ORIGINATION FORM

Proposed Revisions to a Standard Plans Index (Please provide all information — Incomplete forms will be returned)

Index Number: 715-003
Sheet Number (s): All (1-3)
Index Title: Utility Conflict Pole

New Standard Plans Index for a different light pole type.

LIGHT POLE - ELEVATION

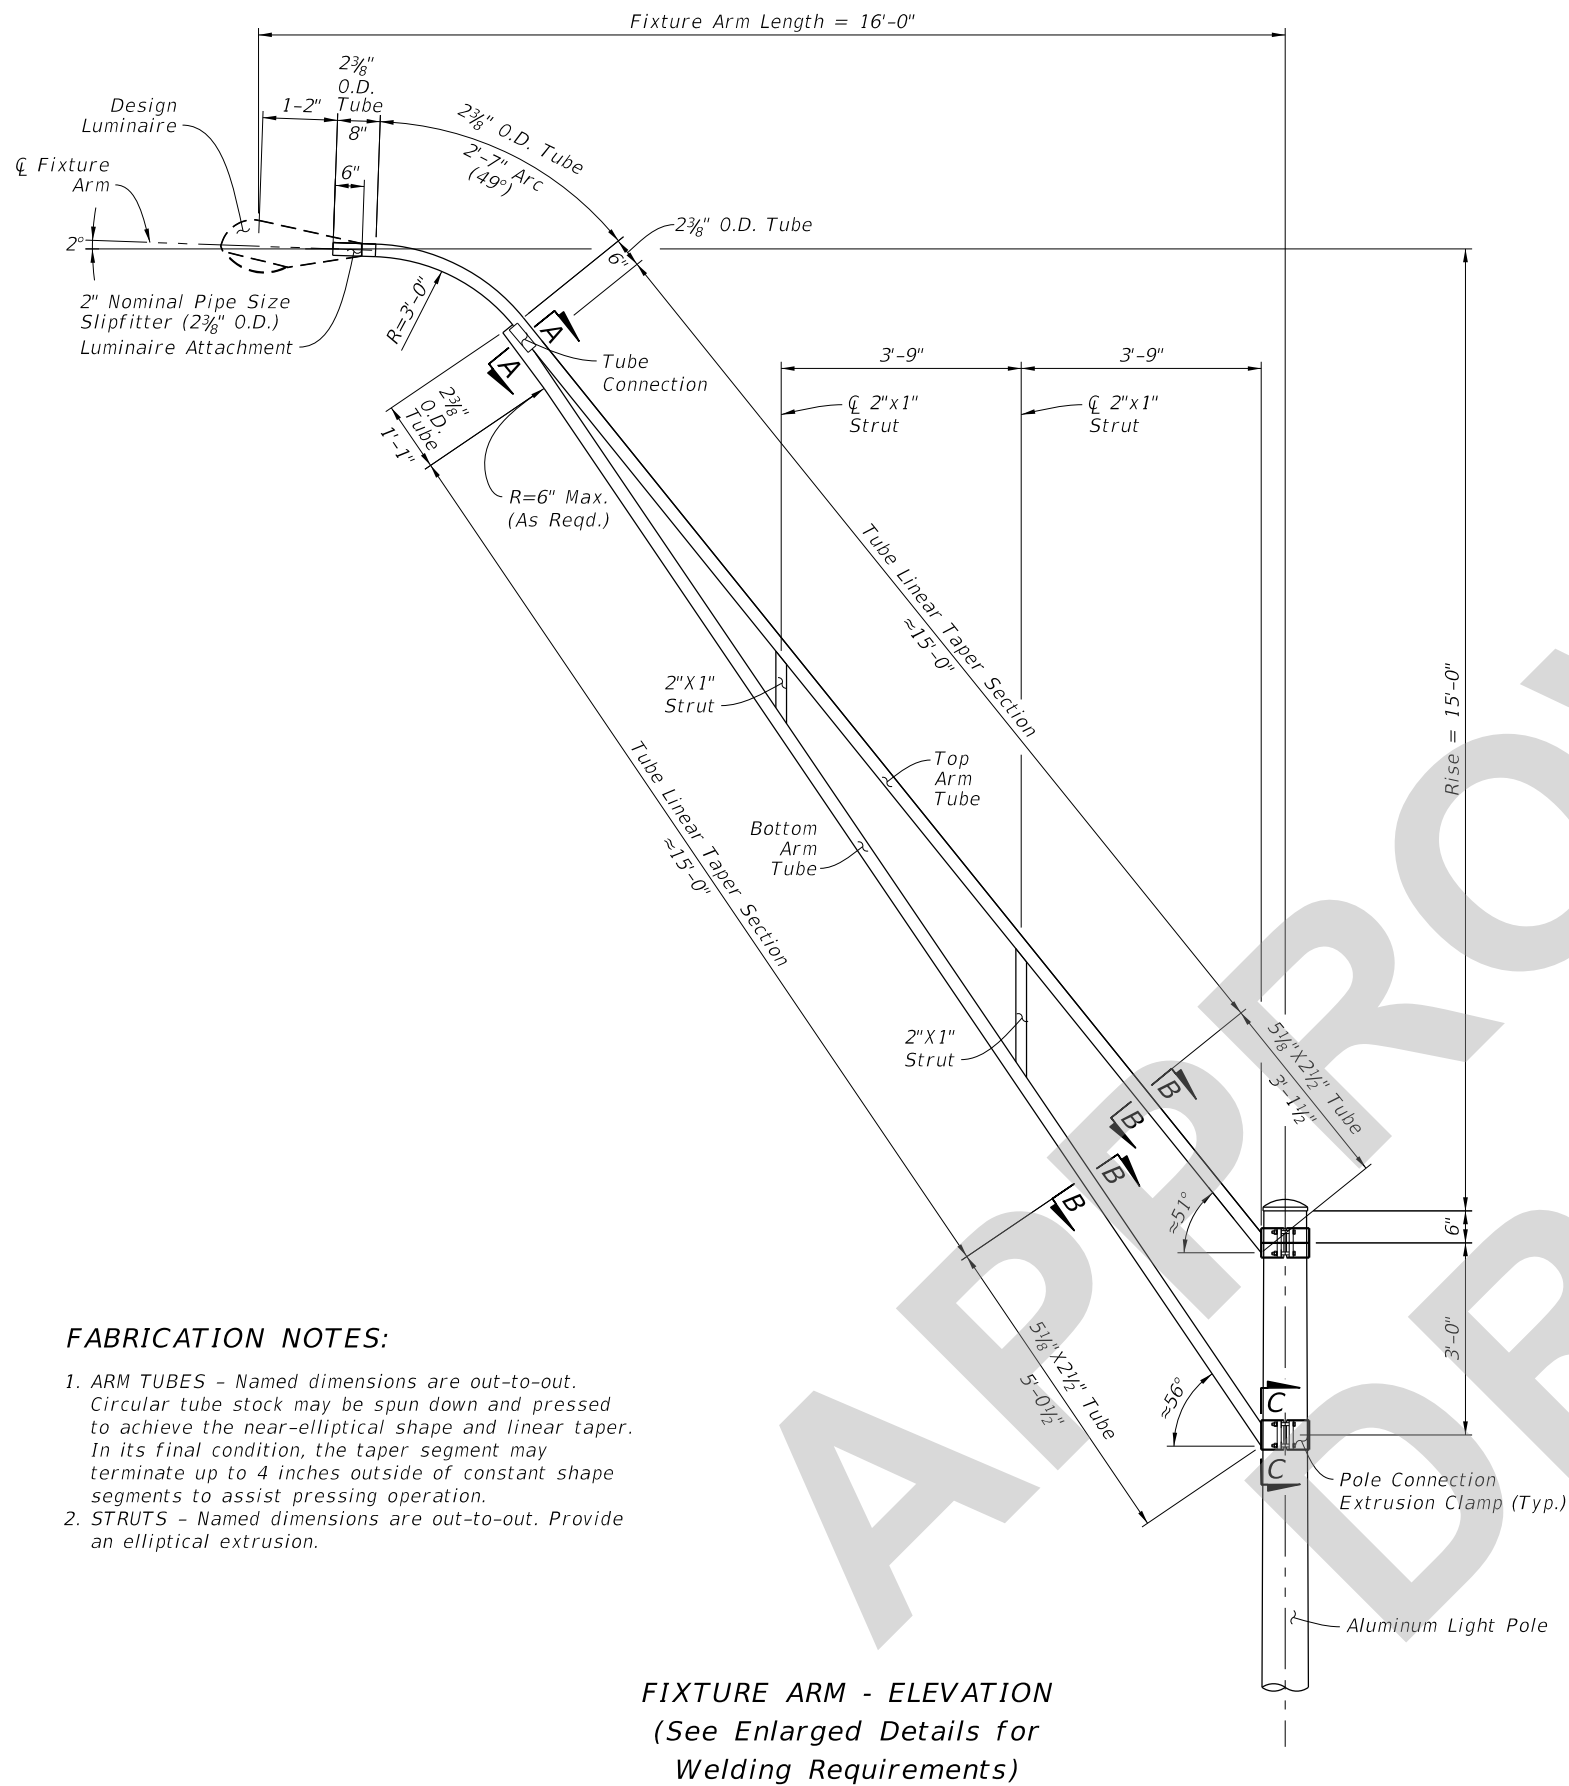
This new pole type has fixture arm dimensions of 16-foot horizontal by 15-foot rise to assist designers with avoiding overhead power lines and other utilities when conventional poles won't fit these project constraints.
